Notice of Changes to the Uniform Dwelling Code

(March 6, 2009)

The following is a summary of changes in the revised Uniform Dwelling Code (UDC), Chs. Comm 20-25, **effective April 1, 2009**. The UDC is generally applicable to one- and two-family dwellings originally built after June 1, 1980, except for energy requirements that began December 1, 1978. (Municipalities may adopt the UDC or some other code to apply to alterations and additions to older dwellings.) These changes have been reviewed and approved by the Dwelling Code Council, a governor-appointed advisory council composed of builders, designers, code officials, labor representatives, subcontractors and others. Refer to the official code for details of the code.

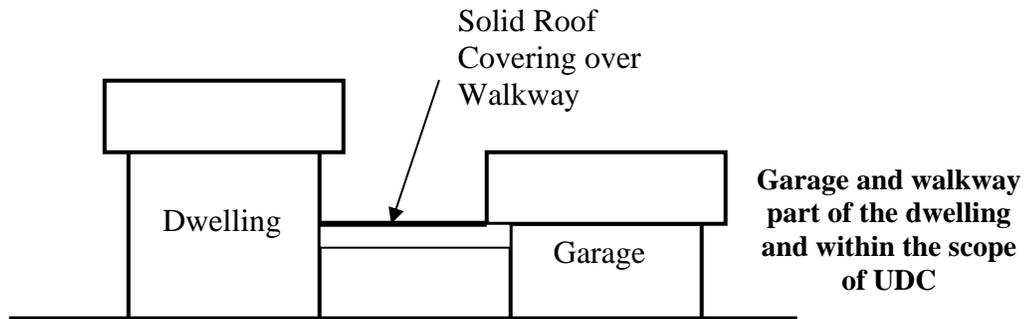
5. 20.05(6) – Clarifies that only those farm buildings not used for habitation are exempt from the UDC.
6. **20.05(9)** - Exempts from the UDC, those motor homes and recreational vehicles that are, or have been, titled by the Wisconsin Department of Transportation (DOT). Note that in order to be titled by DOT, recreational vehicles require a towbar (hitch), chassis, axles and wheels for transportation. At the installation site, the chassis and axles shall remain on the unit, with the towbar (hitch) and wheels left at the site. Otherwise the unit, including a so-called park model, is subject to

the UDC. Additionally, any additions, with a roof, to a motor home or recreational vehicle are considered dwellings that shall comply with the UDC.

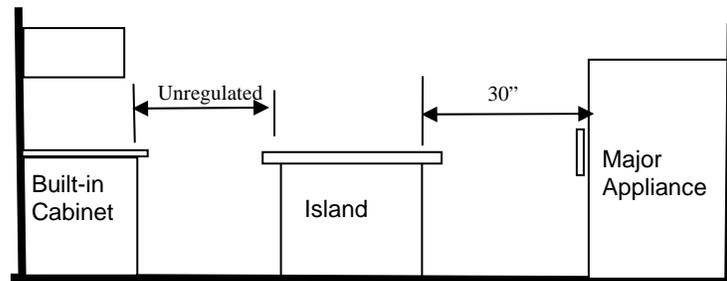
29. 21.035 (1) (c) 2. Requires that if there is a full bathroom on the first floor, then it shall have the minimum doorway widths per this section.
30. 21.035 (2) Clarifies that you may infringe 4 ½ inches on both sides into the 36” minimum width of a hallway. Higher than that, infringements are unlimited.

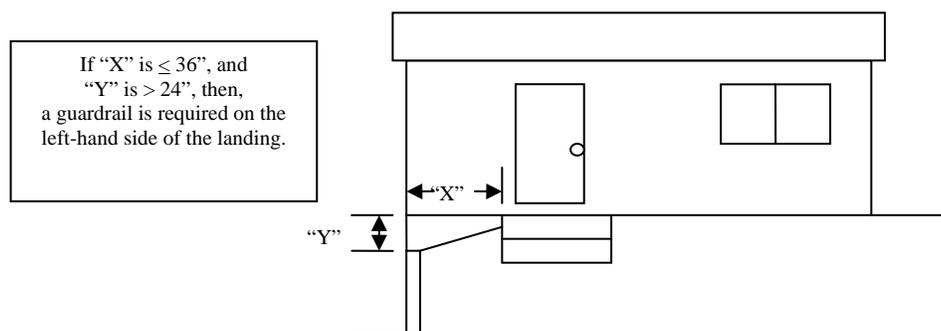
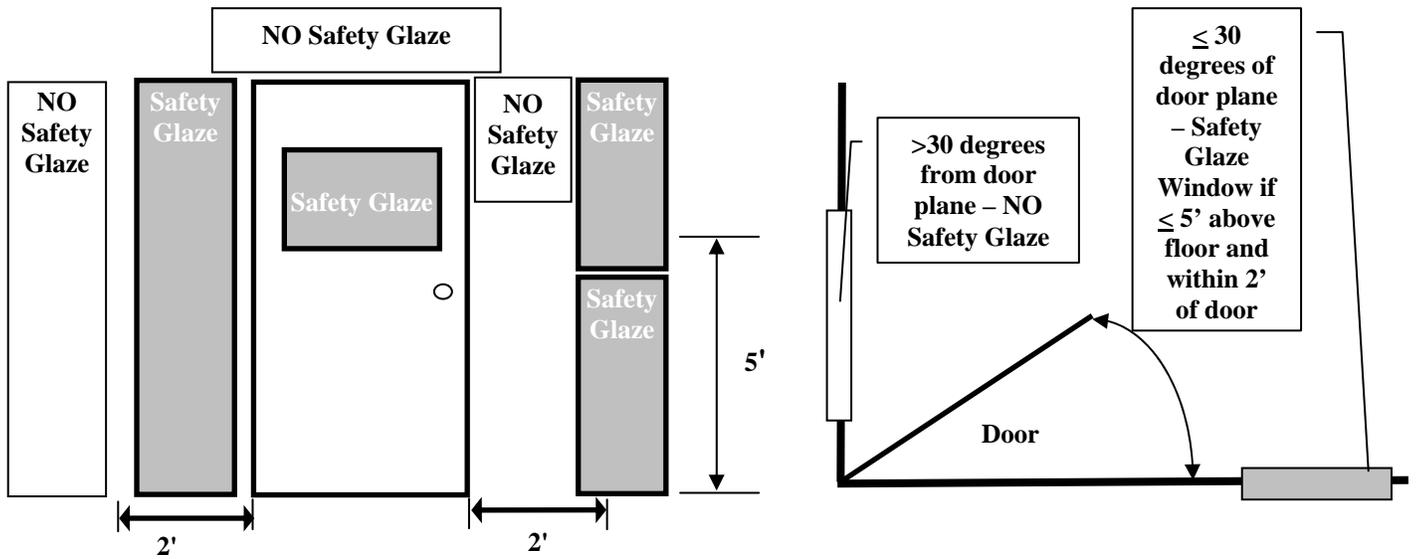
38. **21.04 (3) (c) 1. c. Clarifies that the 24 inch vertical drop-off measurement that triggers guardrails is taken from the lowest point within 3 feet horizontally of the edge of the landing, deck, porch, etc.**

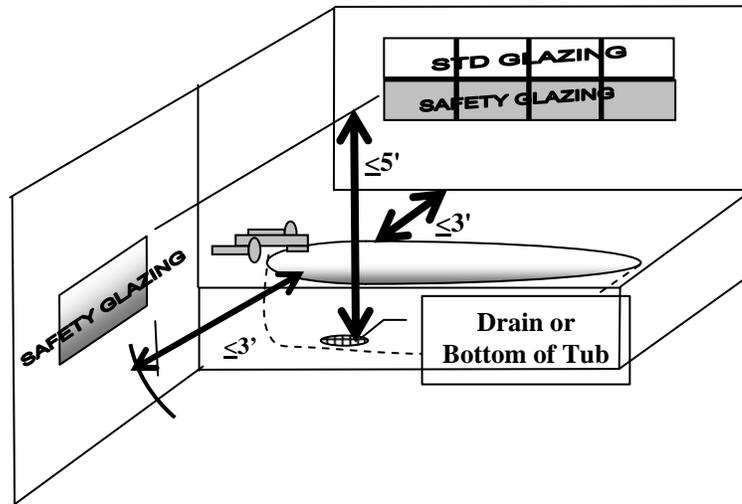
39. **21.05 (3) (intro) Modifies this section to reference the latest standard for safety glazing – CPSC 16 CFR, part 1201, which means that most wired glass will not meet safety glazing standards.**
40. **21.05 (3) (a) Modifies the safety glazing requirements so that it is required for a sidelight or glazing that is within 2 feet horizontally of the door and is within 5 feet of the floor and is in a plane within 30 degrees of the plane of the closed door.**

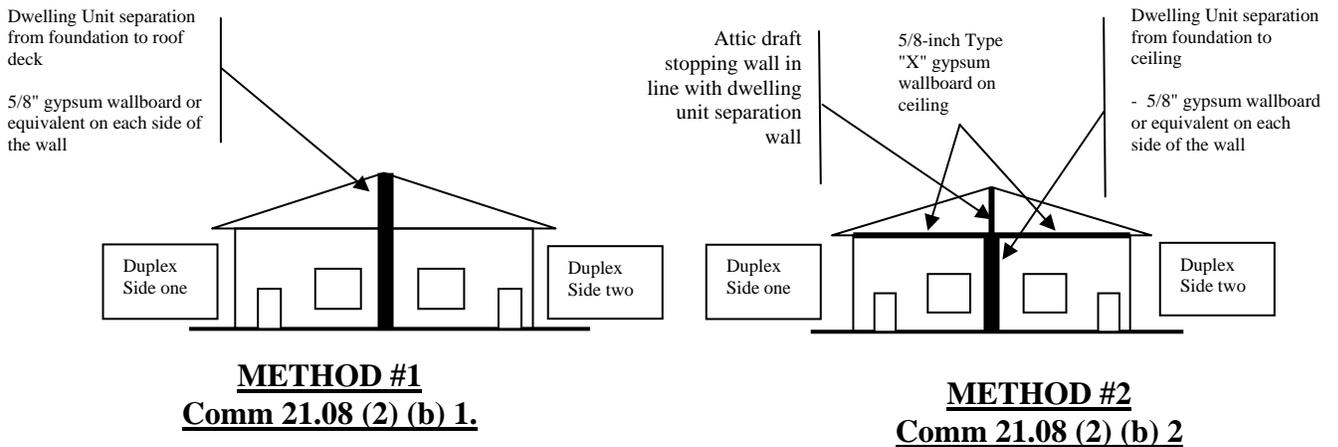
- 42. **21.08 (1) (intro. & Table) Changes fire separation requirements for zero-lot line dwellings to only require one shared wall rated for the equivalent of one hour.**
- 43. 21.08 (1) (a) 4. Repeals the statement that adjoining garage units are not required to be separated from each other. (In most cases this will still be acceptable, except where the dwelling unit separation in a duplex is placed between adjoining garage units.)
- 44. 21.08 (1) (c) Adds requirements for glazing to be fire-rating listed when installed in the wall between an attached garage and a dwelling.
- 45. 21.08 (1) (d) 1. Allows attic access openings in garages to be protected with a material with a finish rating of 20 minutes or more. As before, it shall have hinges and a latch but not necessarily a self-closer.
- 46. 21.08 (2) (b) Clarifies different types of attic separation.

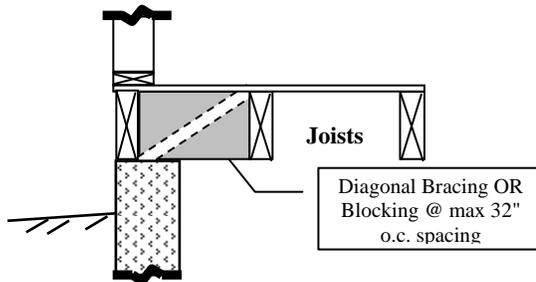
- 54. 21.15 (2) (a) Expands the note in this section to clarify the properties of an unstable soil for purposes of unformed footings.

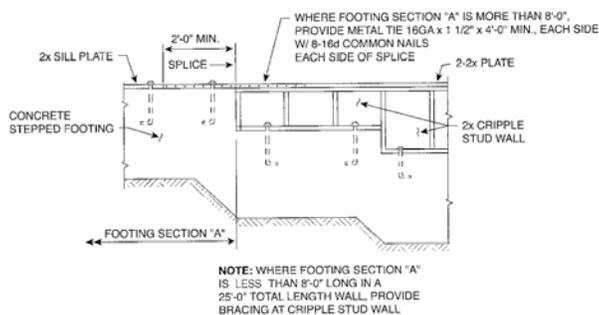
- 69. **21.25 (8) & (9). Expands bracing requirement for dwellings. In addition to requiring bracing at the corners, bracing will be required at no more than 25 foot intervals in the braced wall line and braced wall lines will need to be provided and spaced no more than 35 feet o.c. An exception is provided to permit the walls to be spaced up to 50 feet o.c. This section also includes a note permitting the alternative use of wall bracing provisions, s. R602.10, of the 2009 International Residential Code (IRC).**
- 70. 21.26 (1). Specifies that cold weather work on masonry walls must conform to adopted standard ACI 530.1.
